ADDRESS: 1601 MOUNT VERNON ST

Proposal: Amend approval of façade materials

Review Requested: Final Approval

OVERVIEW: This application calls for amending the Historical Commission's July 2023 approval for the rehabilitation of the Robert Purvis house. The developer seeks approval to substitute cast stone for marble on the front façade's stoop and door surround, owing to the high cost of marble. The applicant is determining the viability of cast stone for the water table.

Figure 6: The front facade of 1601 Mt. Vernon Street in 2009. Source: Google Streetview.

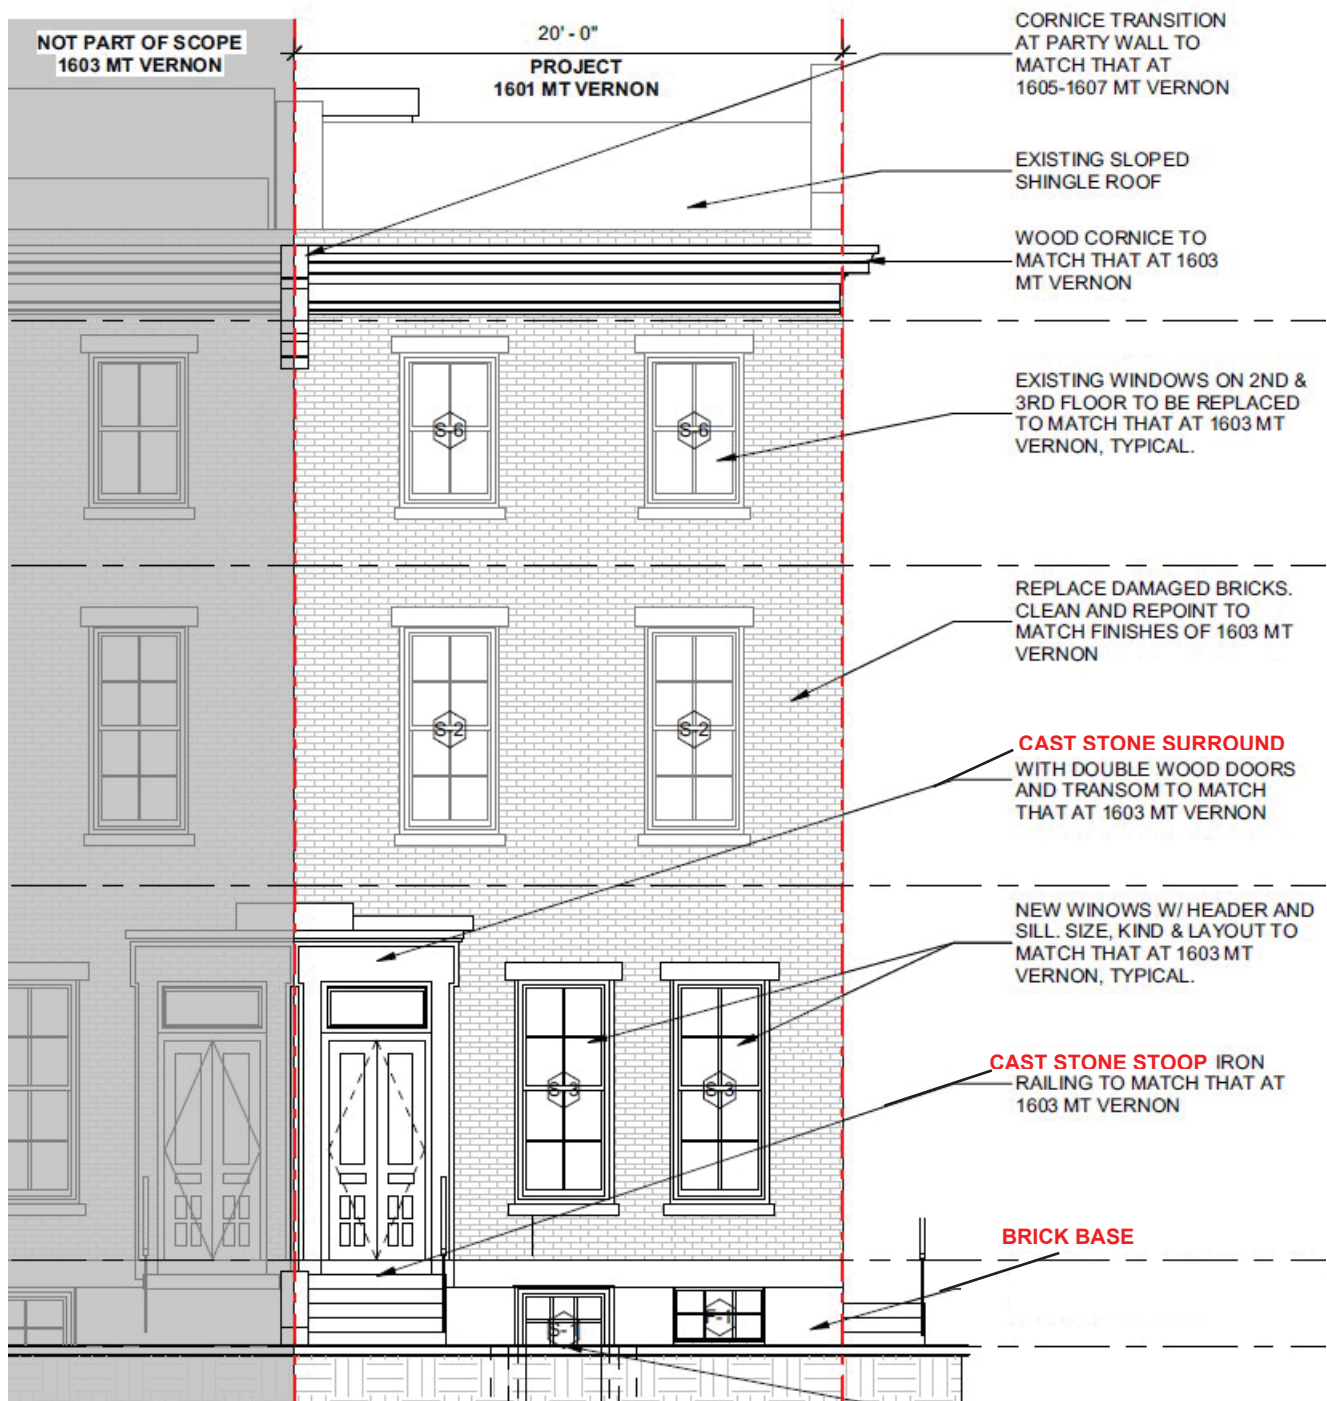
- o The only remaining portion of the original building, the main block, had a storefront installed c. 1920. That intervention removed the original entryway and marble stoop. Two large openings for storefront windows were cut into the masonry on the front façade and side wall at the first story, and a new corner entrance was constructed.

- o The application proposes to substitute the approved marble of the stoop and door surround with cast stone, owing to the high cost of the marble. They are unsure if they will propose cast stone or brick at the water table. While suboptimal, the staff sees the use of cast stone as the best solution to complete construction of the residential front. If cast stone is used for all marble elements on the front façade, the work complies with Standard 6.

STAFF RECOMMENDATION: Approval, if the water table, as well as the surround and stoop are built with cast stone, with the staff to review details, pursuant to Standard 6.
